### REMARKS

Per the Examiner's comments, Applicants are submitting substitute formal drawings to the Draftsperson that include references to elements 58 and 60. For the Examiner's convenience, Applicants have included a redlined copy of these drawings in an appendix to this Amendment and Response.

## Appendix

Redline copy of formal drawings submitted to Draftsperson

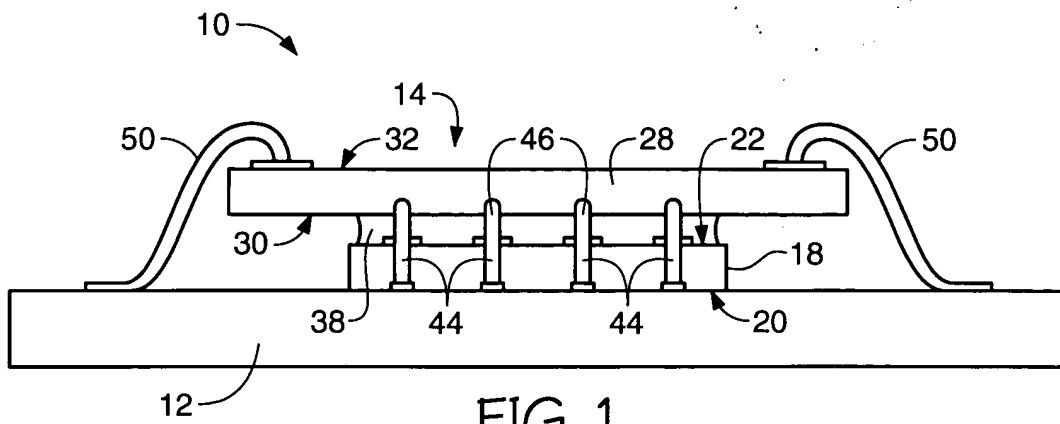
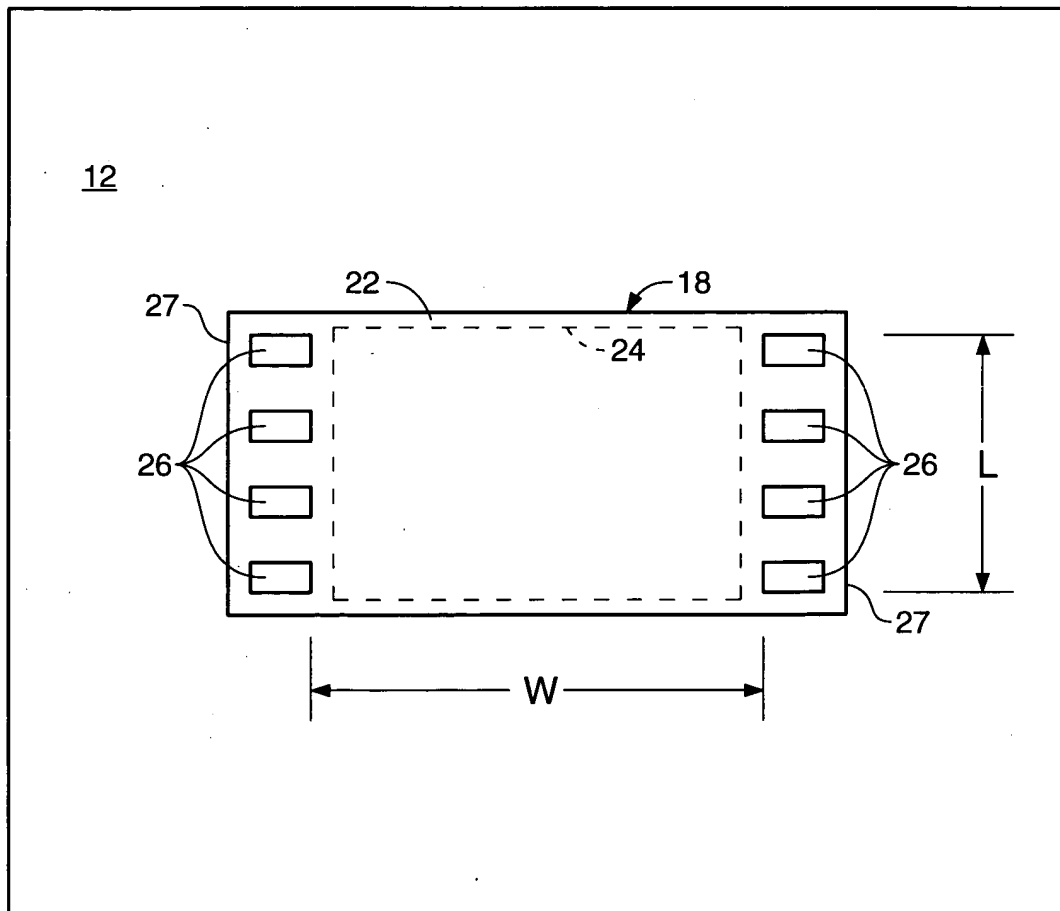
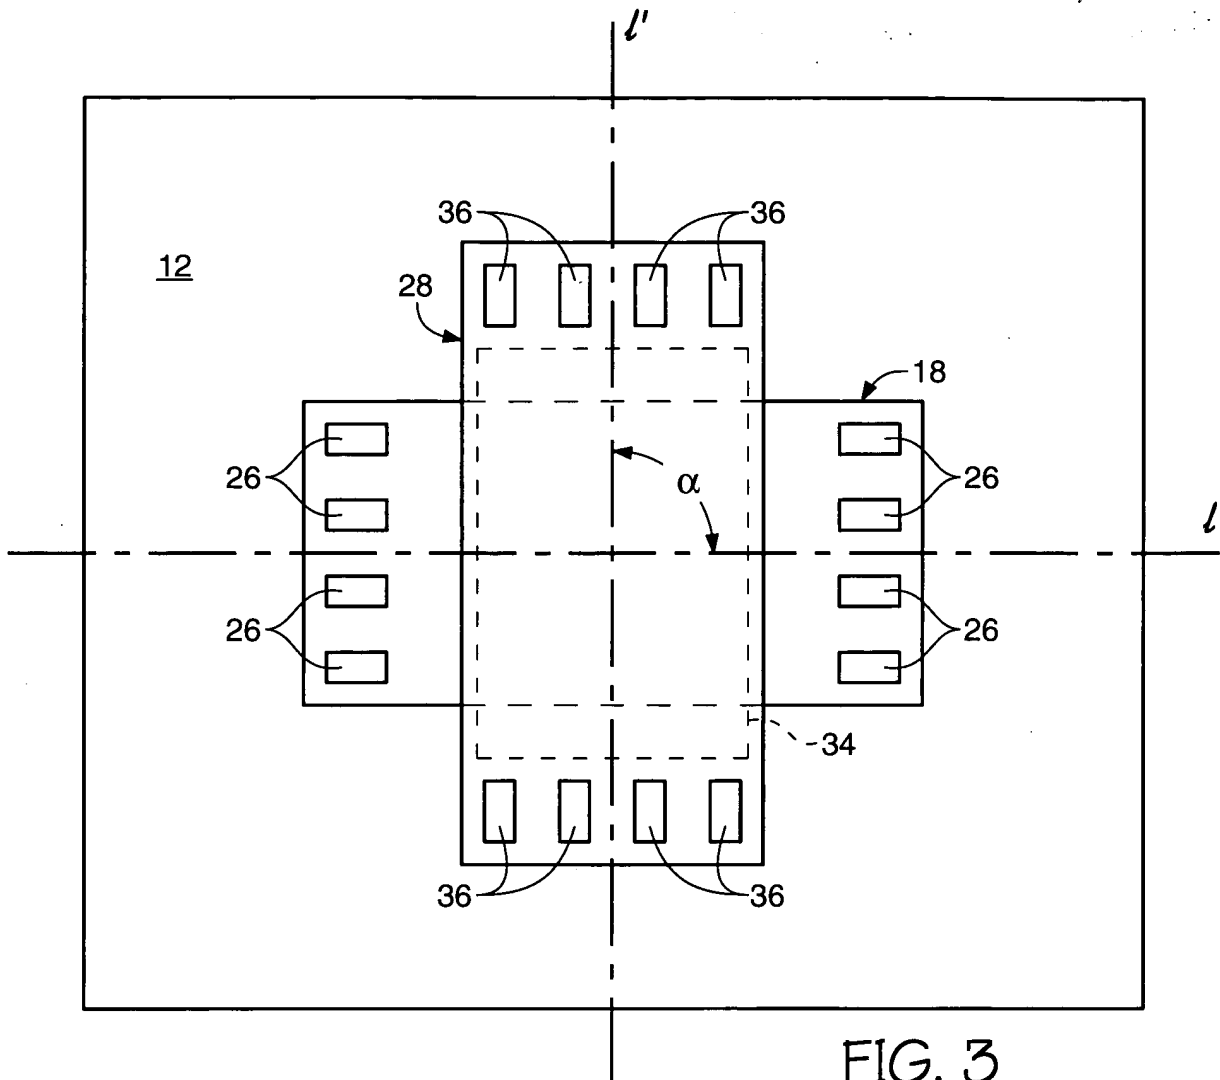
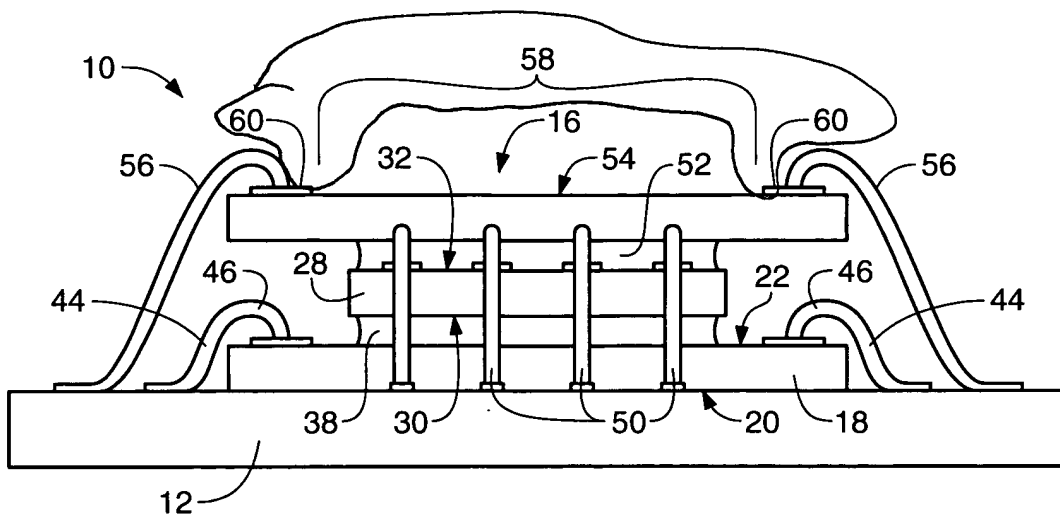
The drawings are objected to.
